Tech Note

TX-E201 & TX-E231 Battery Clip Issue

Applies to Product with Date Code Prior to 18105

Revision 1.0

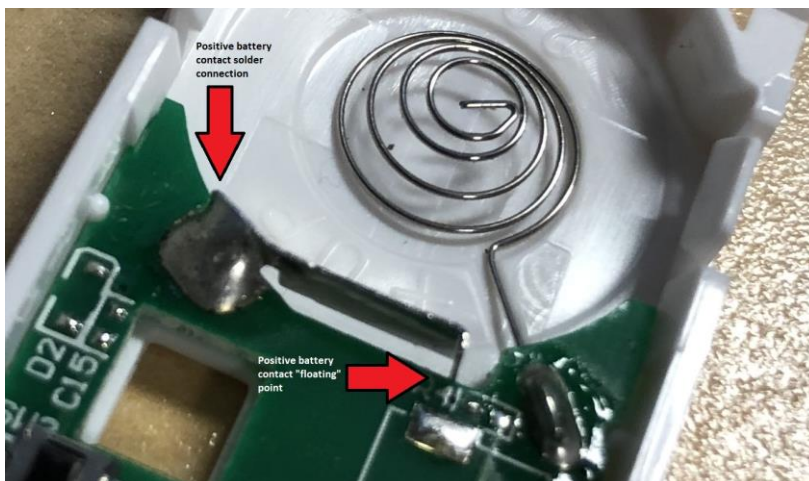
1. Some TX-E201 and TX-E231 units with date codes prior to 18105 may appear to have a “dead” battery, even if battery voltage measurements suggest adequate capacity to operate the sensor.
2. The root causes of this condition have been isolated to two factors: A misalignment of the positive battery contact, and use of a metal material with insufficient stiffness for the positive battery contact.

3. The misalignment of the positive battery contact usually occurs at the factory during production, but can also occur due to product damage in the field. In the factory case, the positive battery contact can be soldered with incorrect alignment, due to inconsistent or incorrect use of the corresponding soldering fixture. The field misalignment usually occurs when the technician accidentally bends the flimsy positive battery contact away from the battery during battery insertion or extraction.

4. When the battery contact assembly is misaligned, the battery's positive electrode will not make proper contact with the sensor circuit, such that it can sustain normal sensor operation. This condition will give the impression that the battery is "dead".

1. Units with a date code on or after 18105 have been built with a stiffer metal for the positive battery contact, using a more robust production fixture and rigorous soldering strategy.
2. Do not to use any TX-E201 or TX-E231 Door/Window Sensor units with misaligned battery contacts.
3. Utilize the normal RMA process to return the affected units for replacement.
